Access Compliance Report

Public Rights-of-Way

(Curb Ramps)

Intersection ID: 23101	Main Street: LYNBRIDGE_DR	Cross Street: PROVIDENCE_RD	Location: SW
ADA ID: CBF0373A9524	Ramp Type: Perp	Initial Pass/Fail: Fail	Overall Compliance: No
Severity Score: 21.25			
Codes/Mitigation Info/Possible Solution		Field Measurements/Component Compliance

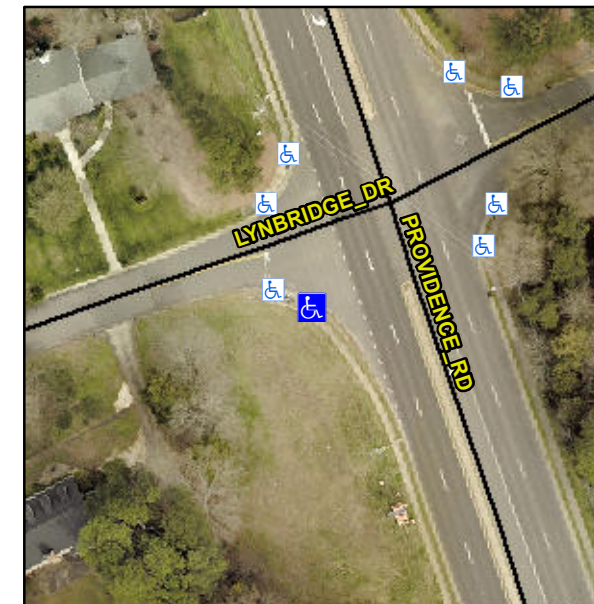
R304.5.1, R304.2.2

Compliance	Description	Data	Compliance	Description	Data
N/A	Ramp Length (in)	72.0	No	Ramp Slope (%)	10.2
No	Ramp Width (in)	43.5	Yes	Ramp XSlope (%)	0.5
N/A	Flare Type LT	N/A	N/A	Flare Type RT	N/A
N/A	Flare Slope LT (%)	N/A	N/A	Flare Slope RT (%)	N/A
N/A	Flare Traversable LT?	N/A	N/A	Flare Traversable RT?	N/A
N/A	Landing Length (in)	N/A	N/A	DWS Provided?	N/A
N/A	Landing Width (in)	N/A	N/A	DWS Contrast?	N/A
N/A	Landing Slope (%)	N/A	N/A	DWS Length (in)	N/A
N/A	Landing X Slope (%)	N/A	N/A	DWS Full Width?	N/A
N/A	Landing Curb? (Y/N)	N/A	N/A	DWS Offset (in)	N/A
N/A	Shared Landing?	N/A			
N/A	Gutter Ponding?	N/A	N/A	Gutter Slope (%)	N/A
N/A	Gutter Lip Ht (in)	N/A	N/A	Gutter X Slope (%)	N/A
N/A	Painted X Walk1?	No	N/A	Painted X Walk2?	N/A
	X Walk 1 Direction	To E		X Walk 2 Direction	N/A
N/A	X Walk 1 Width (in)	N/A	N/A	X Walk 2 Width (in)	N/A
	X Walk 1 Slope (%)	2.3		X Walk 2 Slope (%)	N/A
	X Walk 1 X Slope (%)	2.6		X Walk 2 X Slope (%)	N/A

Remove & Replace Entire Ramp.
